HERITAGE VAUGHAN COMMITTEE – APRIL 21, 2021**COMMUNICATIONS****Distributed April 14, 2021**

**Re: Heritage Vaughan Committee – April 21, 2021, 2298118 Ontario Inc.
7714 Yonge Street, City File DA.14.009; Reginal File SP-V-016-14**

Report to the Heritage Committee regarding
RENOVATION OF THE EXISTING HERITAGE HOUSE ALONG WITH A
REAR ADDITION at 7714 Yonge Street.

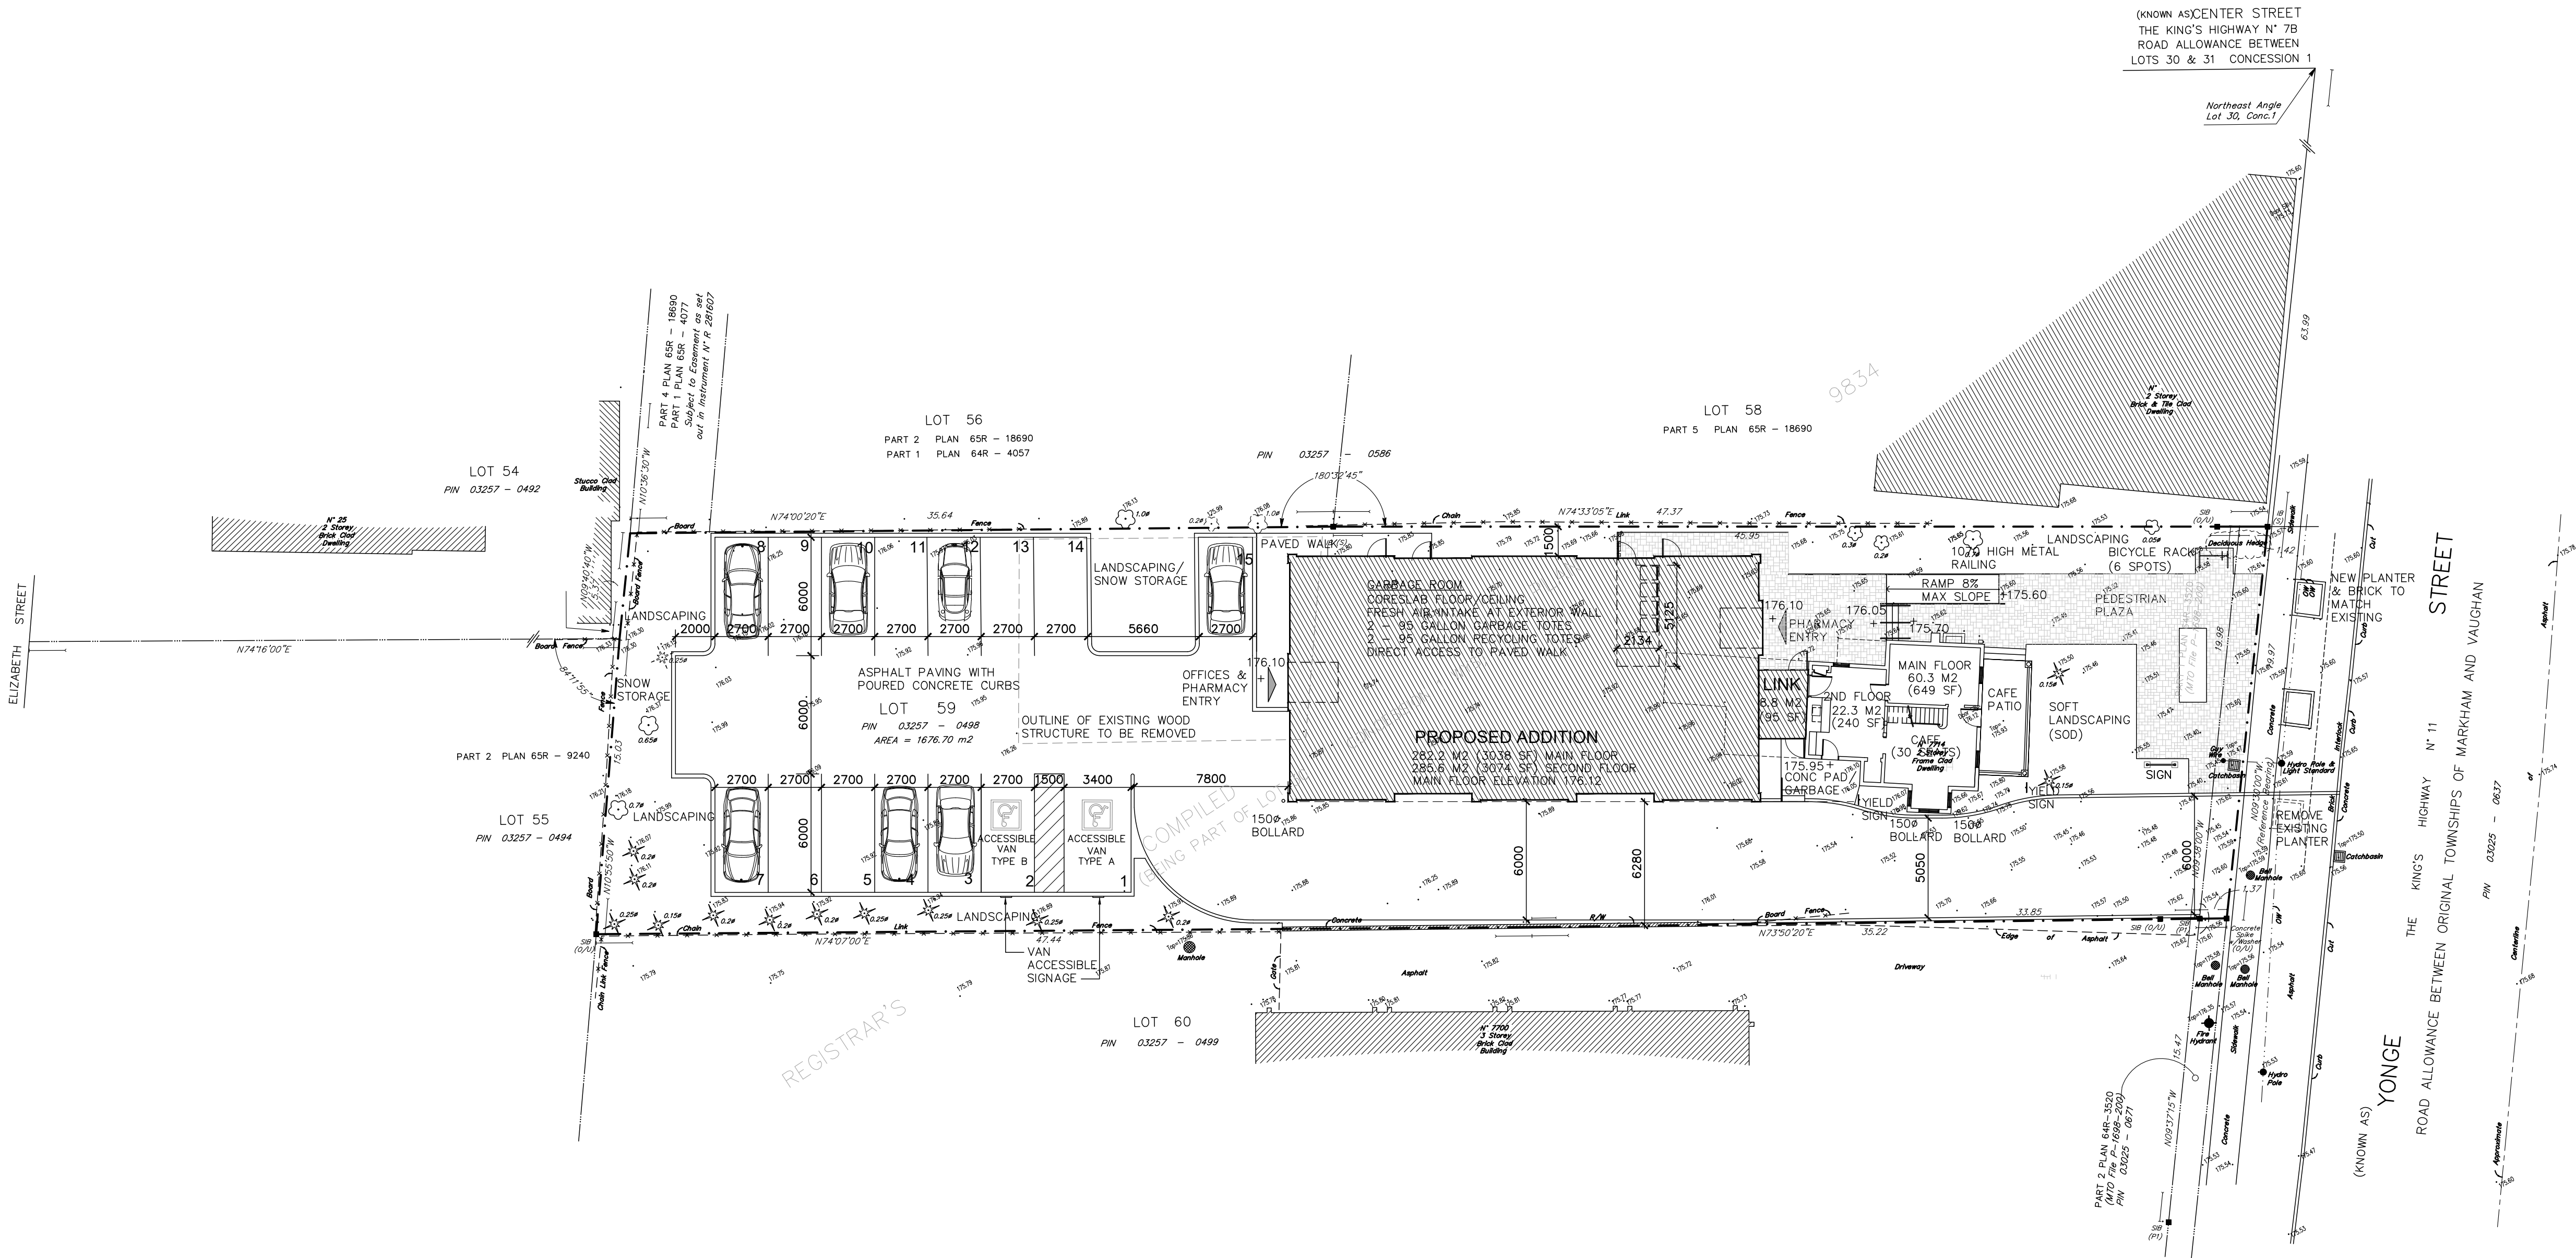
We also heard comments related to the amount of hard surface included as part of the proposed pedestrian plaza immediately adjacent to Yonge Street. Again, we wish to point out that significant effort has gone into planning for the creation of a pedestrian area which will enhance the Yonge Street urban fabric while encouraging members of the public to pause and enjoy the streetscape. We note that approximately half of the proposed pedestrian plaza will feature soft landscaping while the remaining area will be interlocked paving to facilitate mobility and access to the building. For clarity, the site plan has been revised to indicate that the landscape area in the front yard is intended to be soft surface. The rendering has also been updated to remove the north fence and more clearly identify the property line between the subject property and the property to the north.

We were also made aware of concerns regarding bird safety as it relates to the proposed one storey breezeway connecting the new construction. In response, we have made notes on the elevation plan that the breezeway is to include bird friendly glass to prevent bird injuries. Similarly, glass railings in the pedestrian plaza have been removed from the plan.

TREE PRESERVATION PLAN

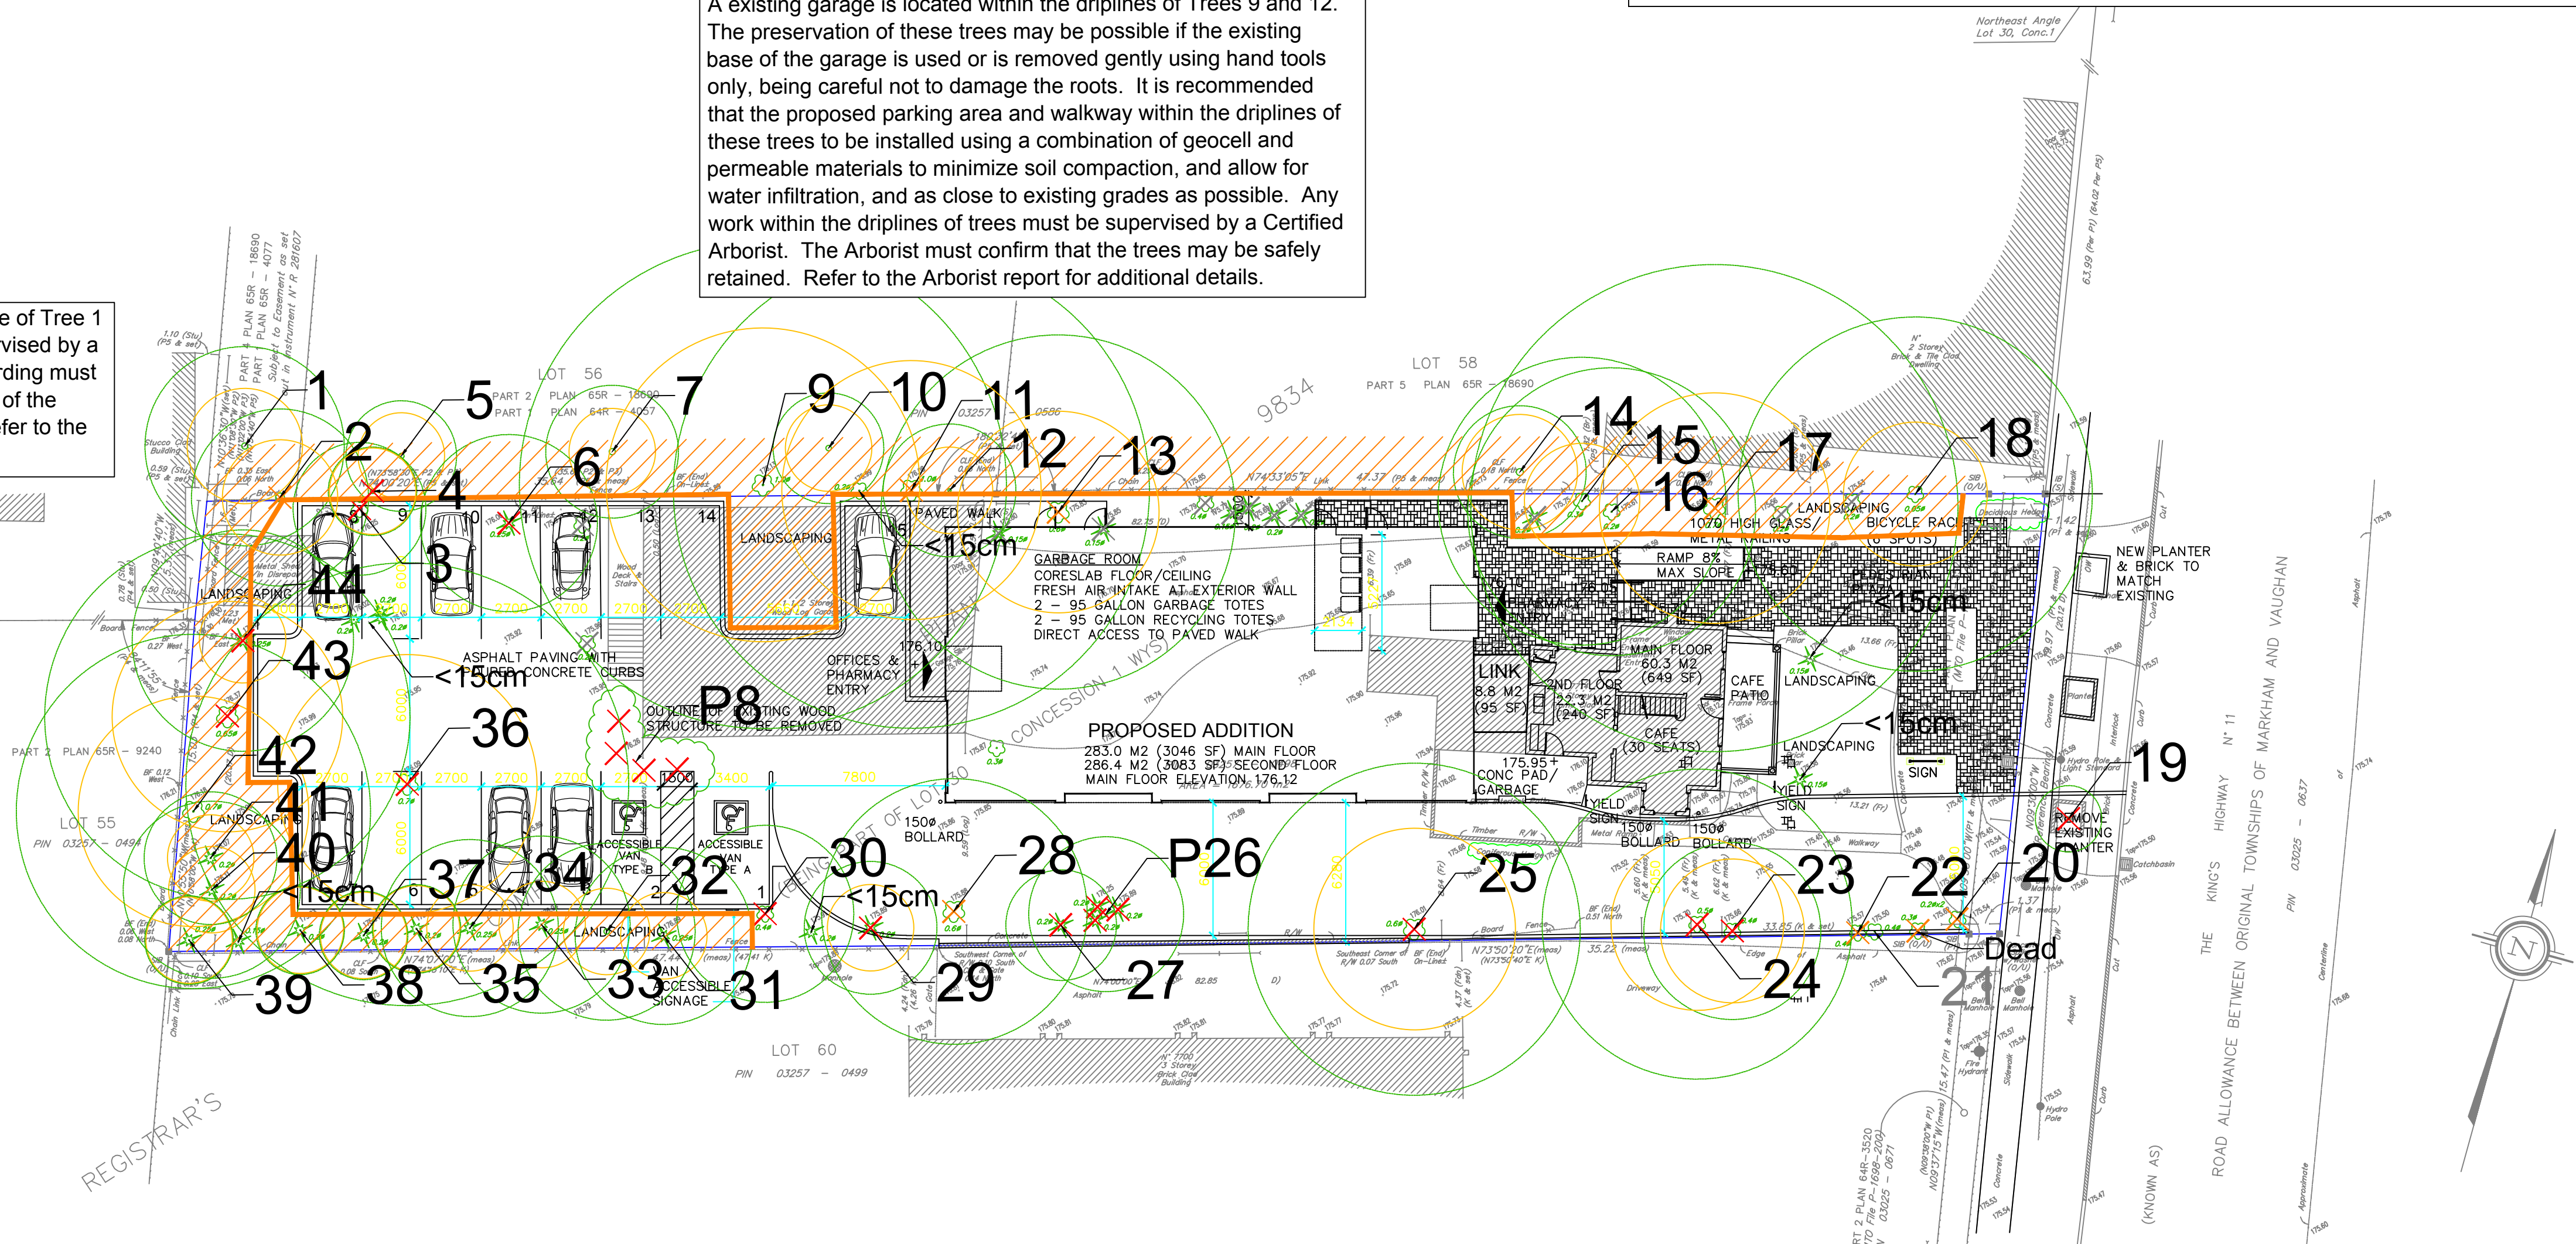
A existing garage is located within the driplines of Trees 9 and 12. The preservation of these trees may be possible if the existing base of the garage is used or is removed gently using hand tools only, being careful not to damage the roots. It is recommended that the proposed parking area and walkway within the driplines of these trees to be installed using a combination of geocell and permeable materials to minimize soil compaction, and allow for water infiltration, and as close to existing grades as possible. Any work within the driplines of trees must be supervised by a Certified Arborist. The Arborist must confirm that the trees may be safely retained. Refer to the Arborist report for additional details.

The concrete pad located within the dripline of Tree 1 is to be removed gently by hand and supervised by a Certified Arborist. The tree protection hoarding must be installed immediately following removal of the concrete pad and prior to construction. Refer to the Arborist report for additional details.

Encroachment into the driplines of Trees 1, 12, 14, 18, 31 to 35, 37, and 38, will be required to accommodate the proposed parking area, walkway, and/or hardscape. Any required excavation should be conducted by hand, air spade or hydro-vac to expose roots for assessment and pruning. It is recommended that the proposed surfaces within the driplines of these trees to be installed using a combination of geocell and permeable materials to minimize soil compaction, and allow for air and water infiltration, and as close to existing grades as possible. Any work within the dripline of trees should be supervised by a Certified Arborist. The Arborist must confirm that the trees may be safely retained. Refer to the Arborist report for additional details.

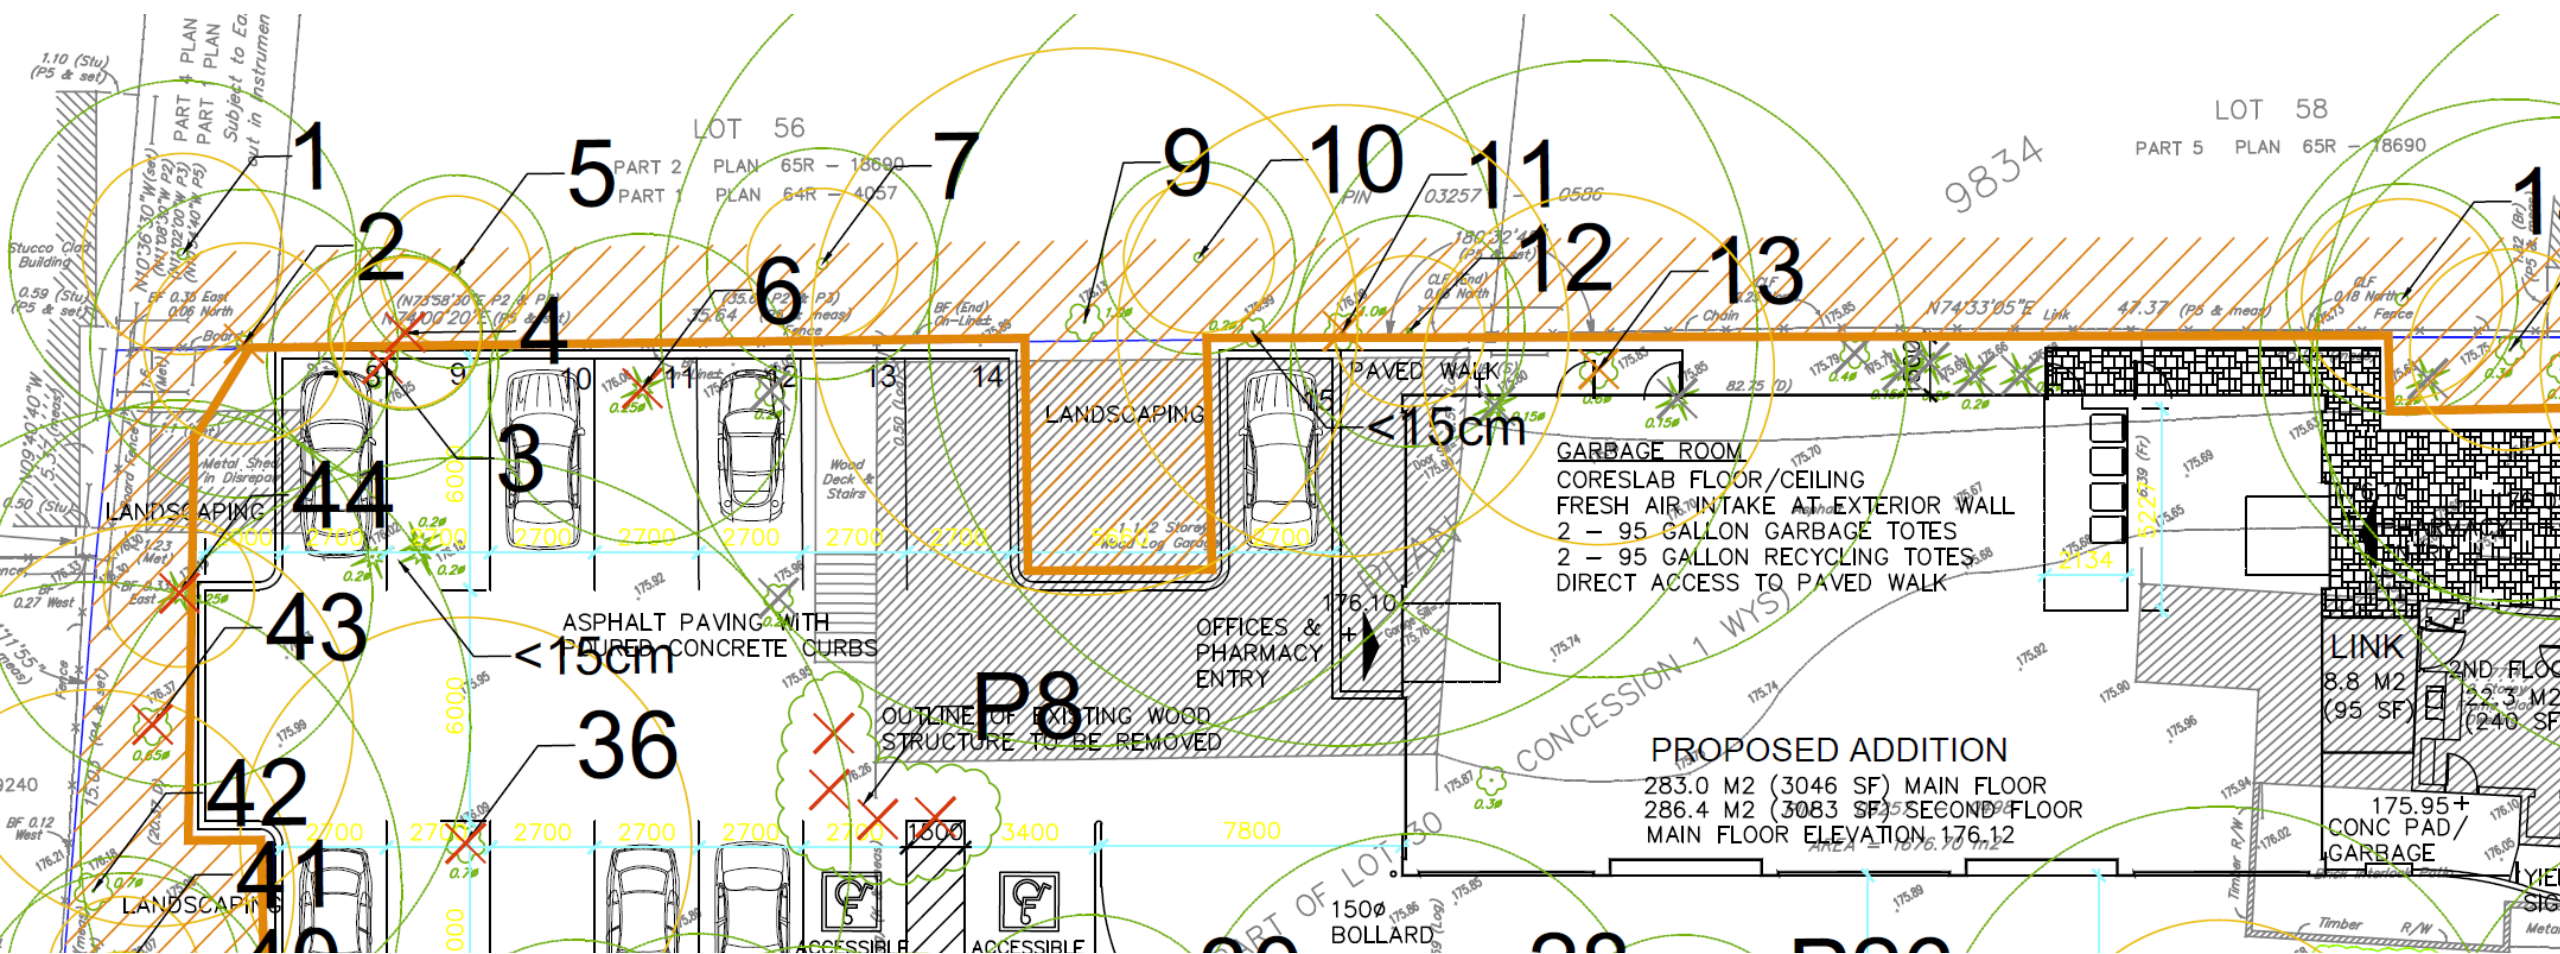
- Inconsistencies between the two arborist reports provided.
- Unconsented recommendations on shared trees in Amy Choi report.
- Inappropriate recommendations on trees that are fully on my property.
